## SERVICE INFORMATION

**APPLICABILITY:** 2015-2017MY WRX 2.0L DIT Models  
 2017MY Forester 2.5L Models

**NUMBER:** 07-88-15R

**SUBJECT:** SOA821B200 Replacement Battery Installation Procedure

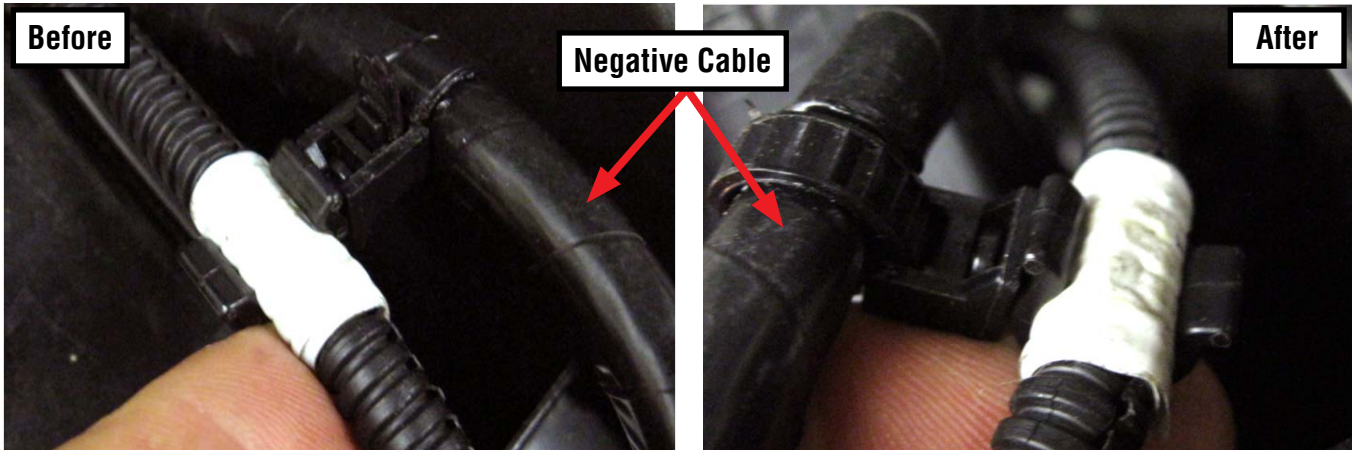
This Service Information bulletin provides a procedure to use when installing a SOA821B200 replacement battery in a 2015MY WRX (2.0L). The sensor located on the battery ground terminal interferes with the battery vent cap used on the replacement battery in the “BEFORE” photo below.

- Disconnect the current sensor harness connector from the negative terminal assembly.
- Remove the 12mm hex nut securing the negative battery cable to the terminal assembly.
- Loosen and lift the battery rod cover off the rod so the negative battery cable is free to move.
- Loosen the 10mm AFTER battery terminal nut and rotate the terminal assembly clockwise to the position shown in the photo on page 3. Re-torque the 10mm terminal nut to 4.4 ft. lbs.

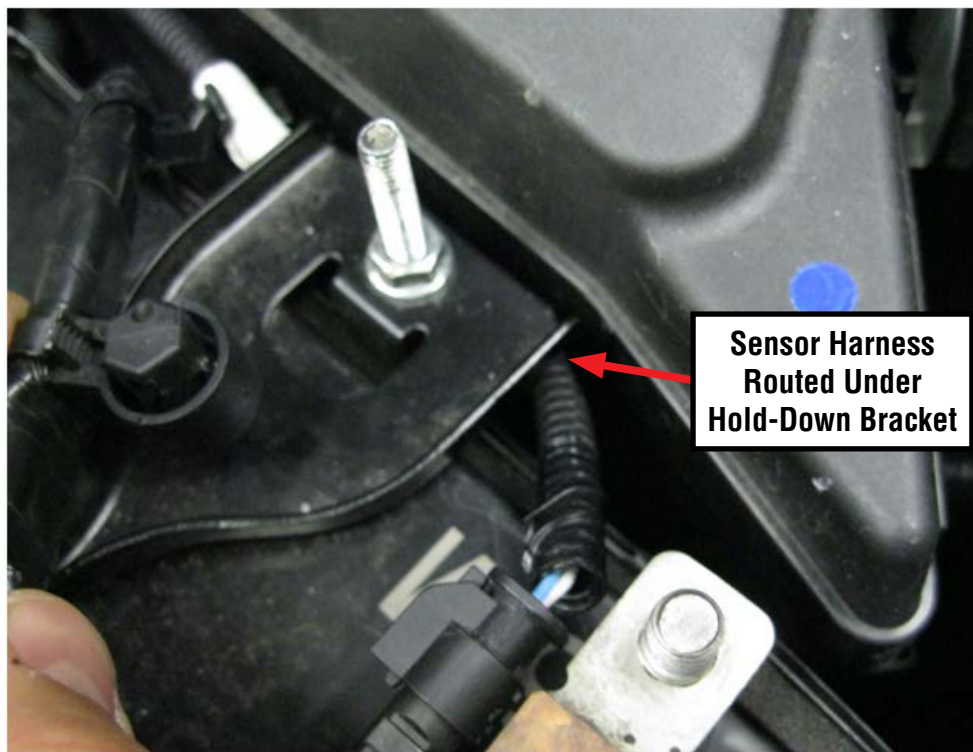
- Rotate and reposition the current sensor harness retaining clip on the negative cable so the harness is now behind the battery hold-down rod and battery cable as shown below.

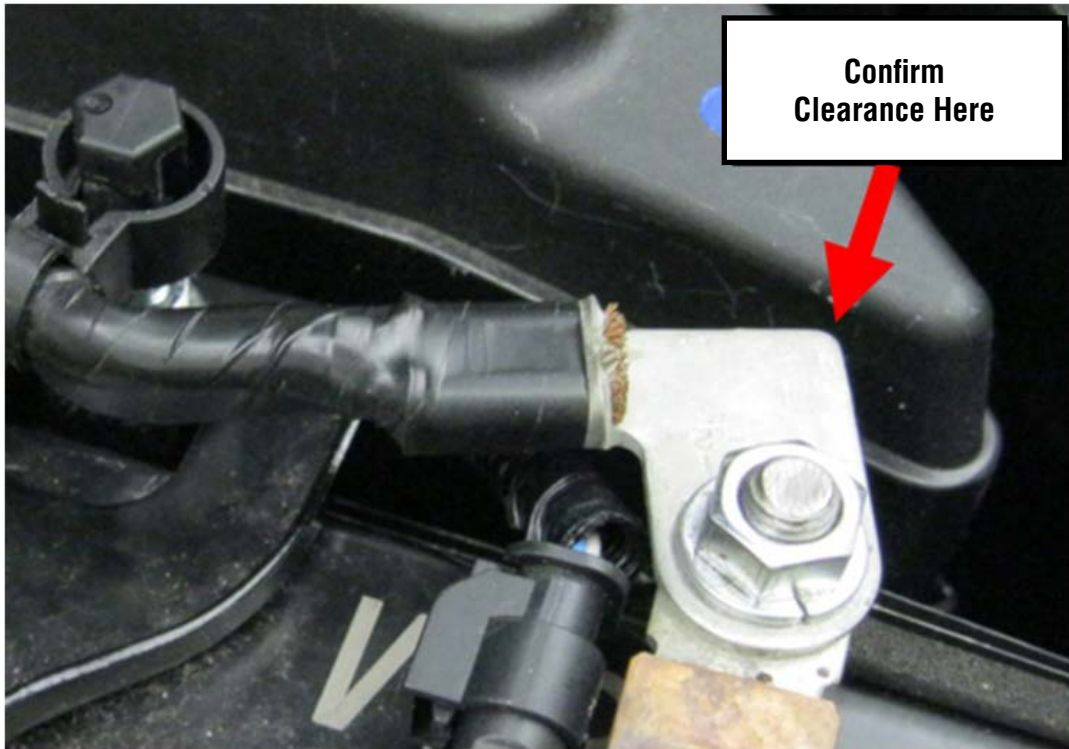
- Route the current sensor harness underneath the battery hold-down bracket with adequate diuis for harness relief then reconnect the harness to the current sensor. Reconnect the harness to the current sensor and make sure there is clearance between the sensor harness and the hold-down rod threads.

- Reinstall the battery rod cover back onto the hold down rod.
- Reinstall the negative battery cable onto the terminal assembly and re-torque the 12mm hex nut to 5.5 ft. lbs.

**NOTE:** If necessary, loosen the front battery hold-down rod nut and re-position the battery slightly to gain clearance between the corner of the negative battery cable end and fuse box cover. If the hold-down rod nut was loosened, re-torque to 2.6 ft. lbs.
